**ADDENDUM No. 2**

**PROJECT NAME:** FIRE STATION # 32 REPLACEMENT, Project No. 20-00015  
**DATE:** March 3, 2015

**ADDENDUM NO. 02**

To the drawings and specifications for:  
Fire Station 32  
4839 Charles Katz Drive,  
San Antonio, Texas

1 FLOOR FINISH PLAN  
1/8" = 1'-0"

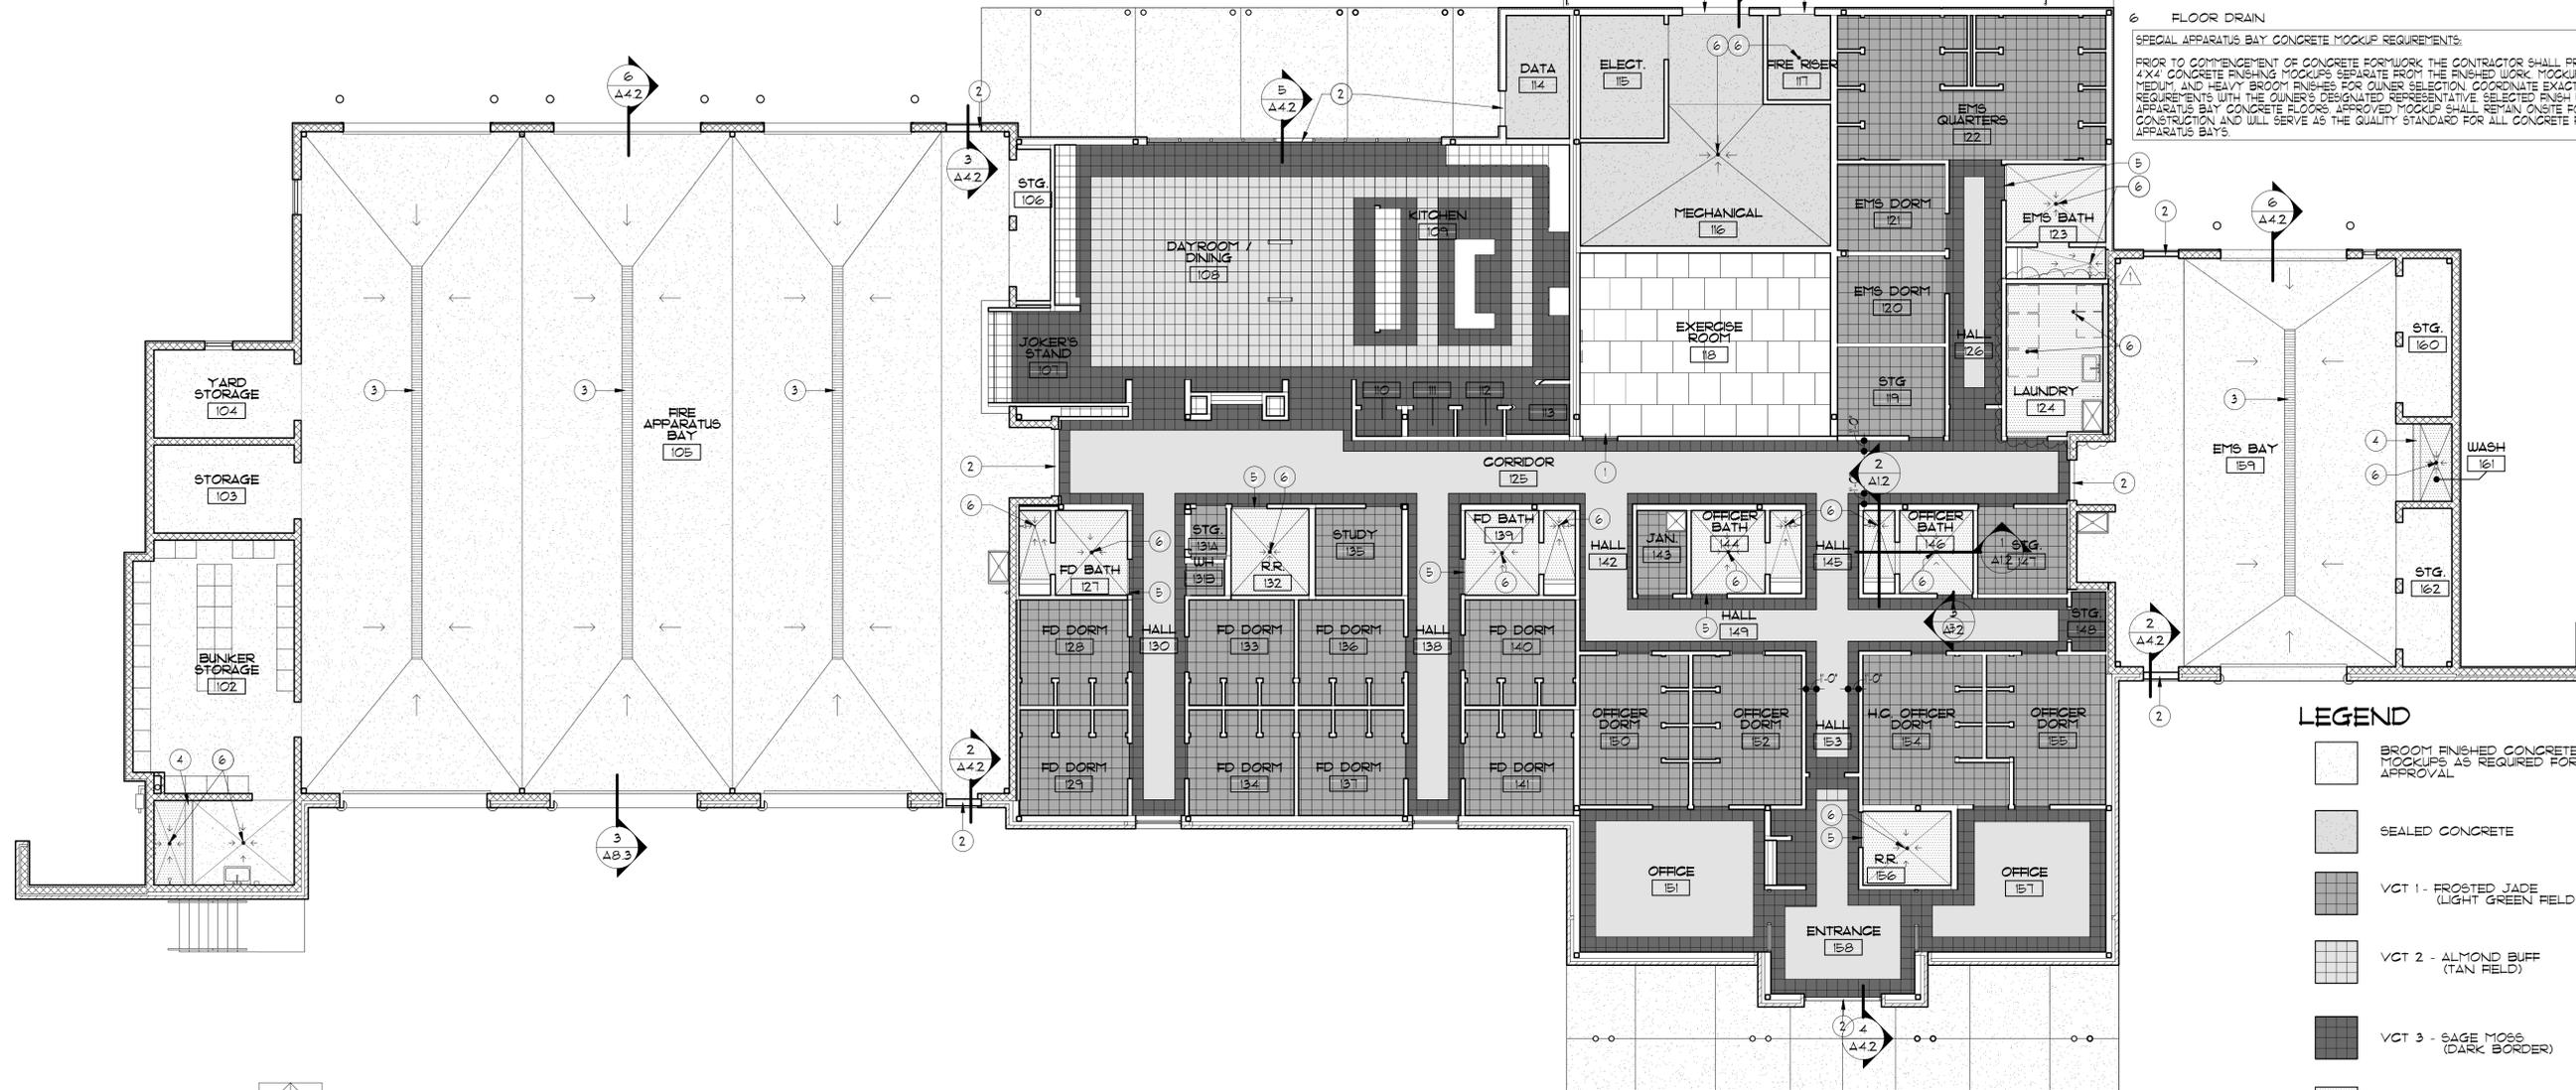
- Item 2.4** Laundry [124] floor finish updated from VCT to resinous flooring. Floor drain added adjacent to Washer/Dryer. Refer to updated sheets A4.2 & P101 Seal dated 03.02.15.

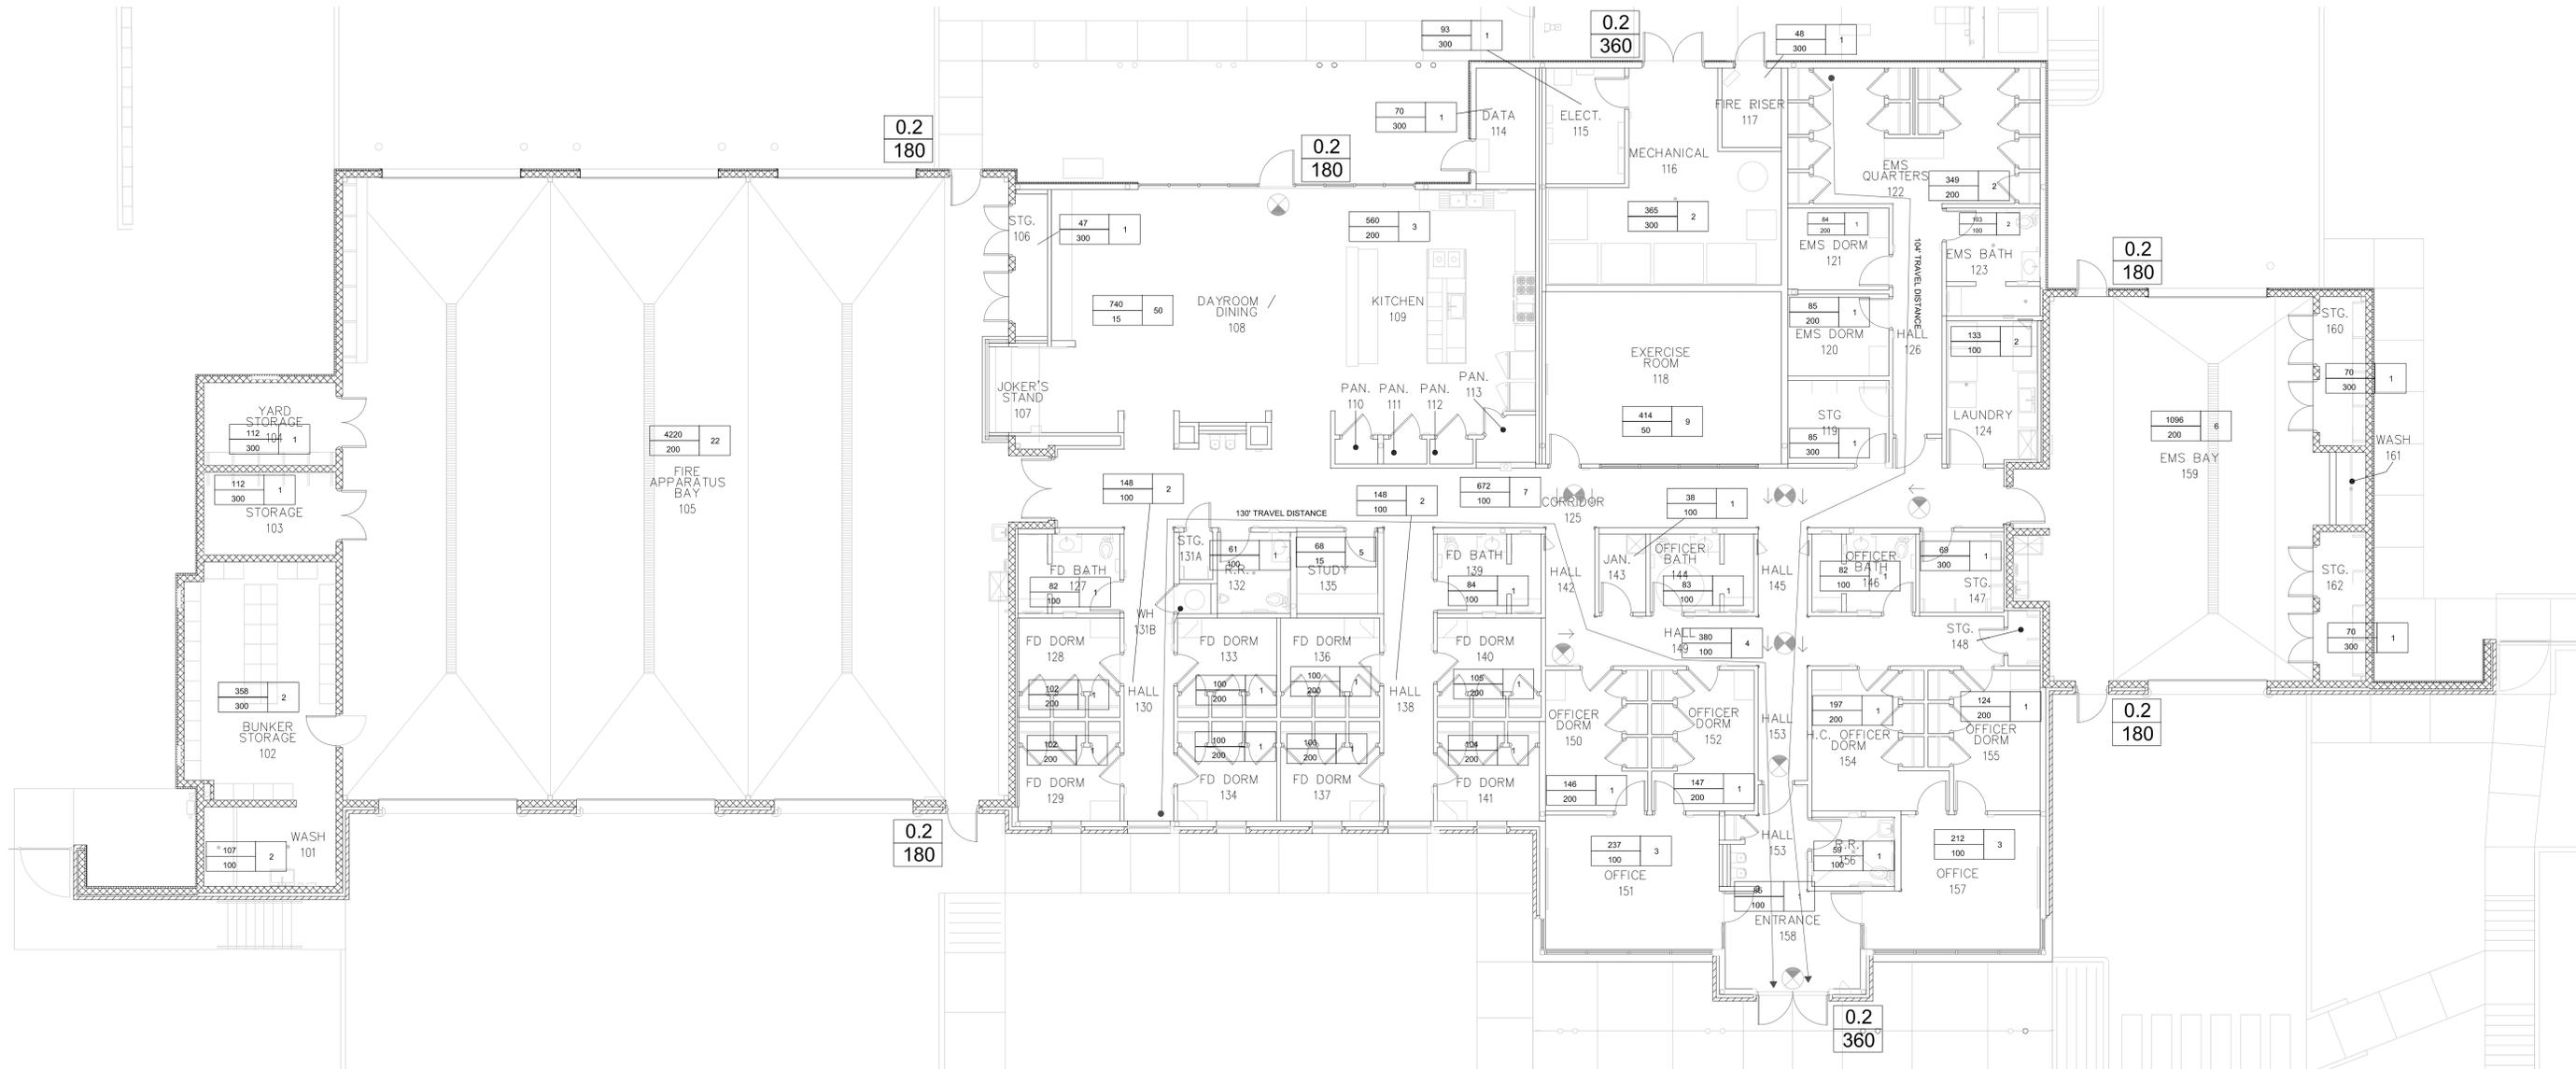
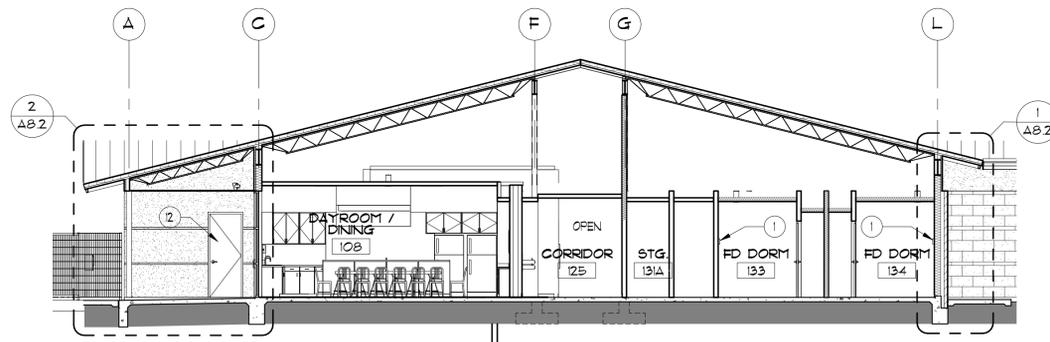
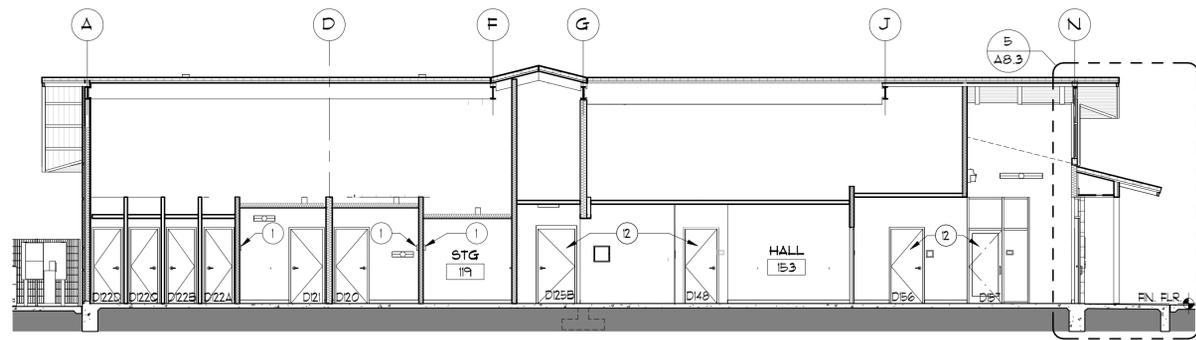
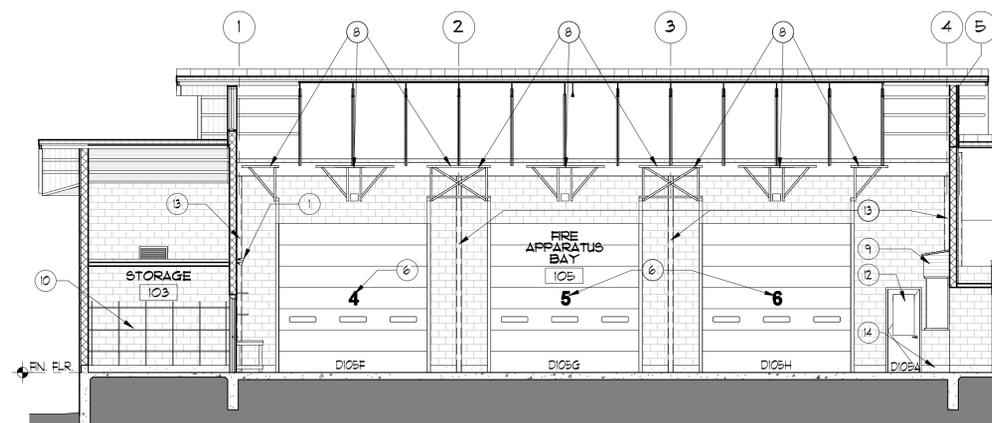
- Item 2.5** Two 24" Towel bars added at Fire Bay & EMS wash areas. Refer to updated sheet A8.1 Seal dated 03.02.15.
